NOAA FORM 76-35A	
U.S. DEPARTMENT OF COMMERCE NATIONAL OCEANIC AND ATMOSPHERIC ADMINISTRATION NATIONAL OCEAN SERVICE	
DESCRIPTIVE REPORT	
Type of Survey .....	Hydrographic
Field No. ....	RA-20-1-97
Registry No. ....	H-10742
LOCALITY	
State .....	Alaska
General Locality .....	Stephens Passage
Sublocality .....	Grand Island and Vicinity
.....	
1997	
CHIEF OF PARTY	
CAPT Alan D. Anderson, NOAA	
LIBRARY & ARCHIVES	
DATE .....	MAY 5 1998

Descriptive Report to Accompany Hydrographic Survey H-10742

## EVALUATION REPORT

H-10742

ATTACHMENT 1  
 H-10742 LIMITS DEPICTED ON CHART 17314,  
 11TH EDITION, May 25, 1991.  
 LIMIT LINE DENOTES AREA OF SUPERSESSON  
 SUPERSEDED AREA OF CHART  
 NOT TO SCALE

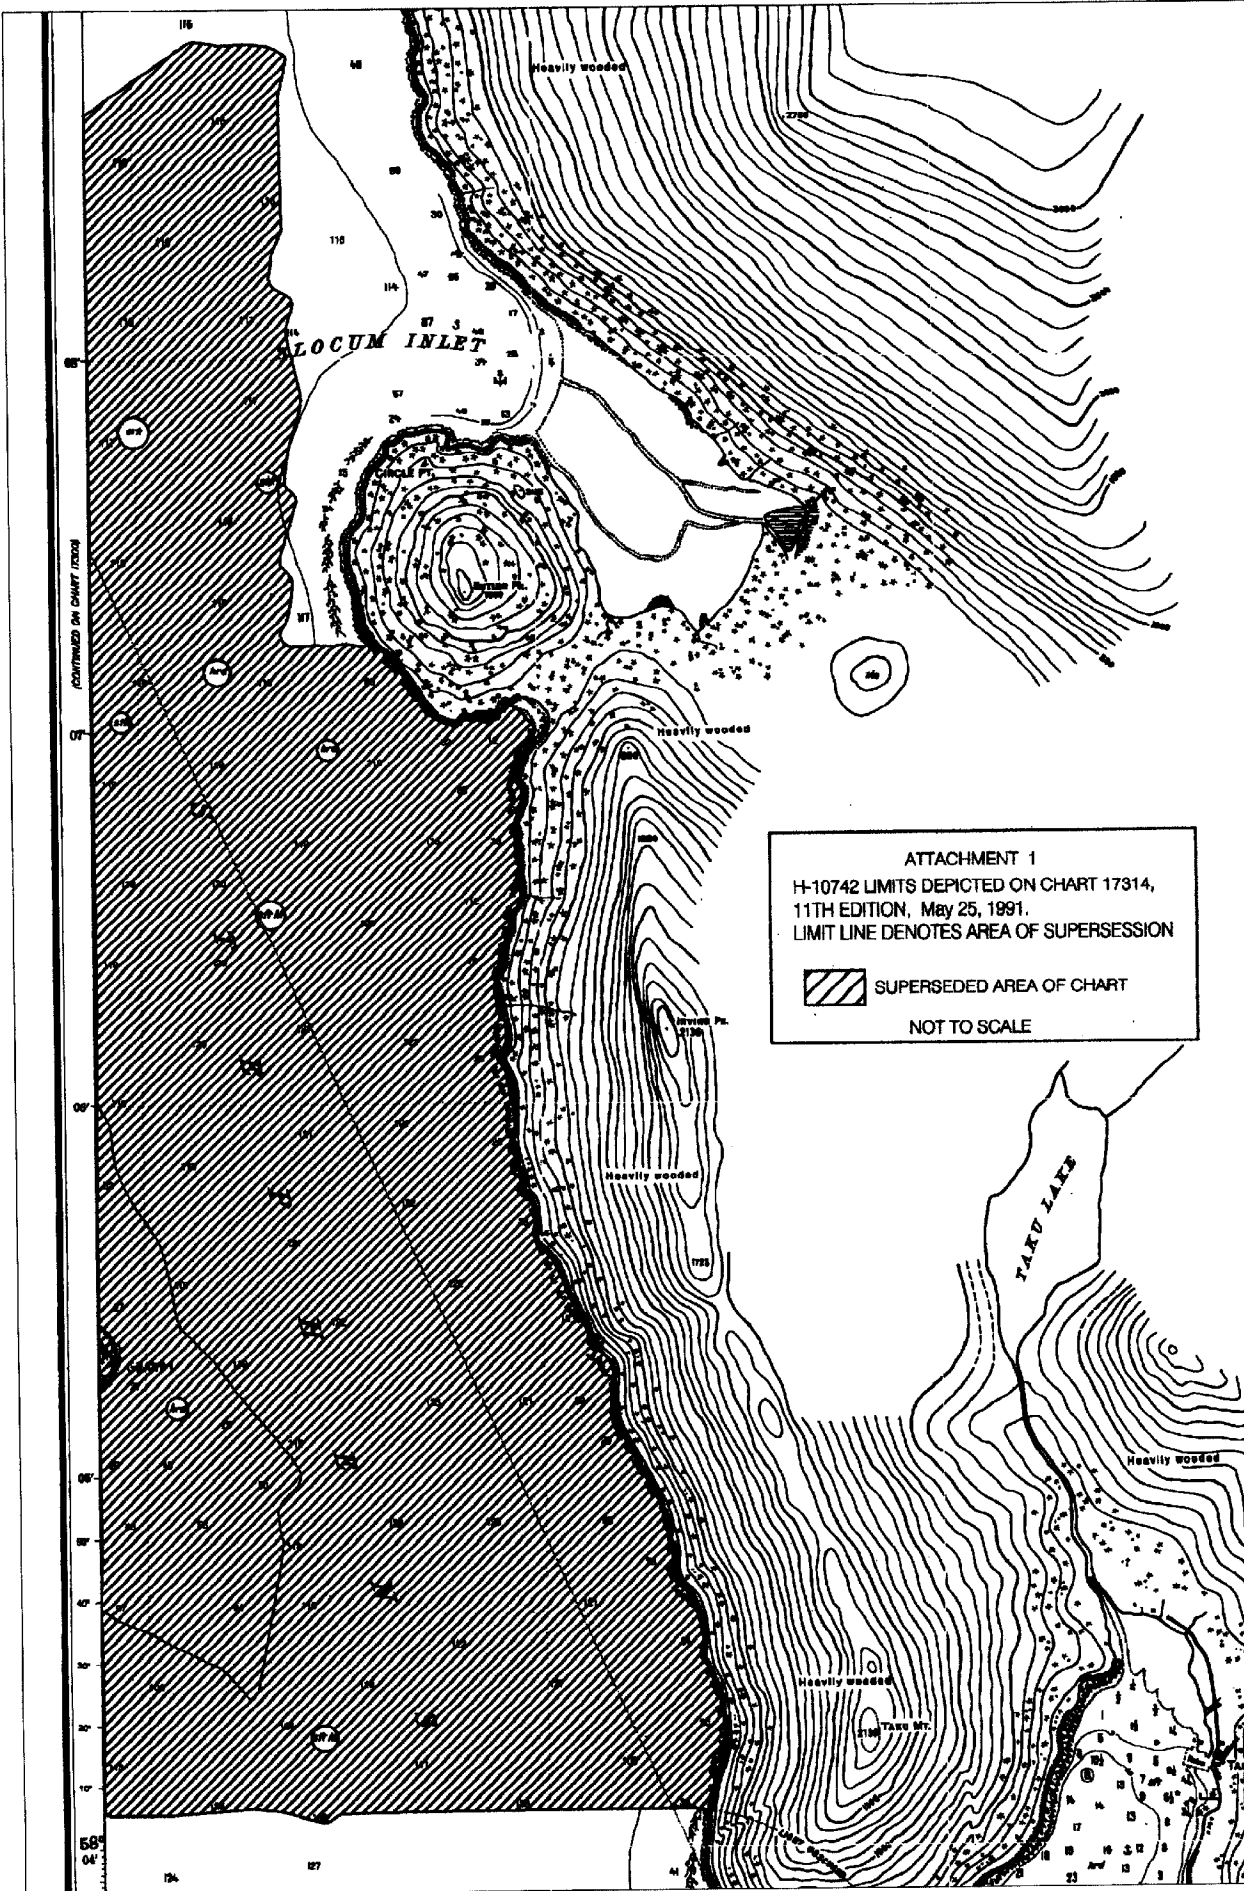
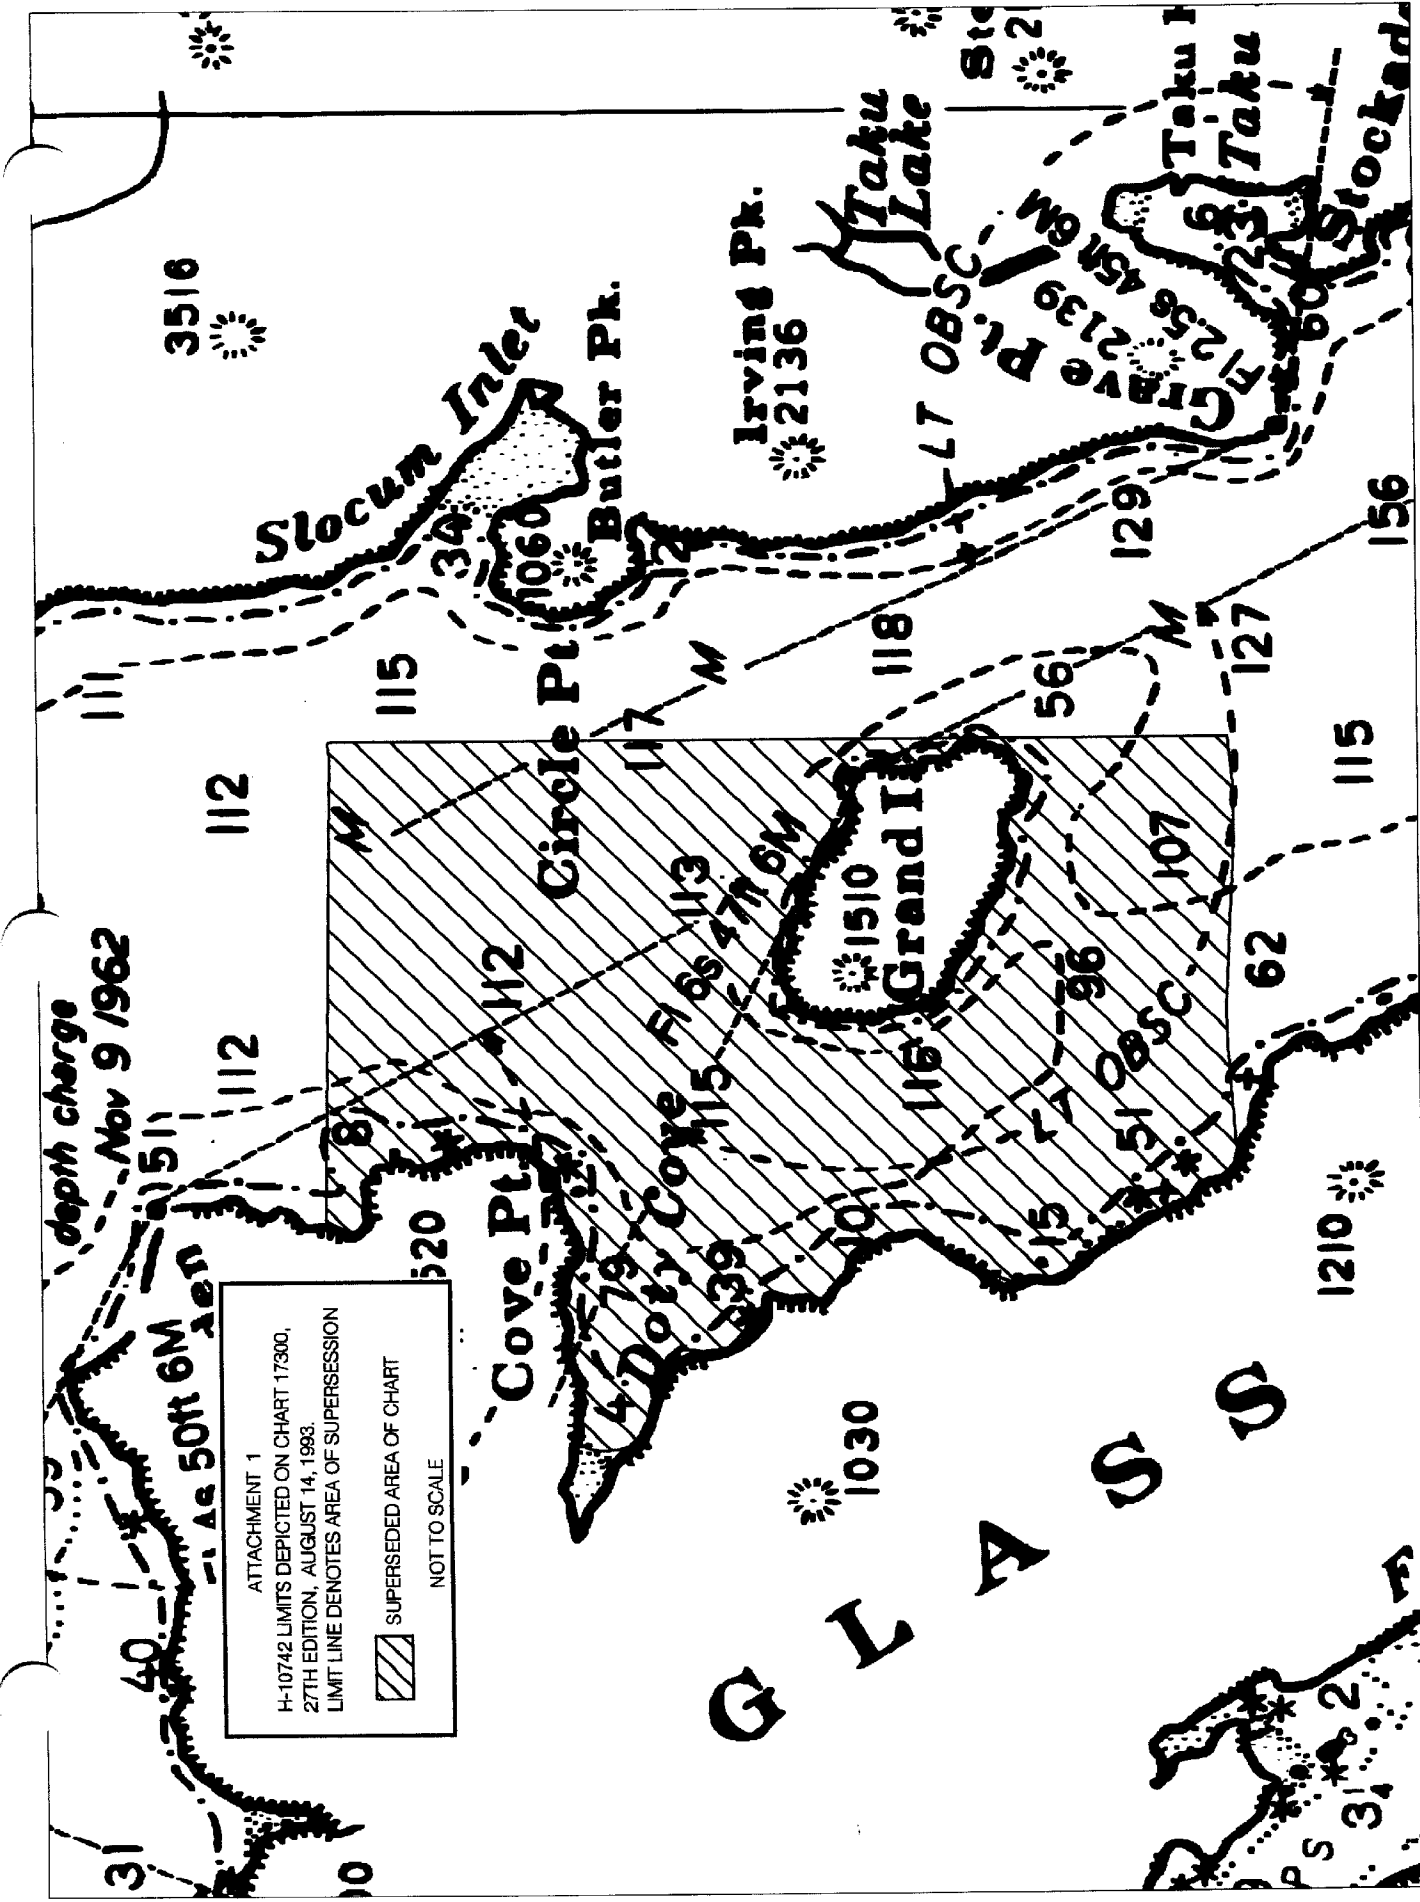
The hydrographer has determined the inshore limits of safe navigation by defining a Navigable Area Limit Line throughout the survey area. Charted features and soundings inshore of this limit line have not been specifically addressed during survey operations and should be retained as charted. Two page-size plots of the charted area depicting the limits of supersession accompany this report as Attachment 1.
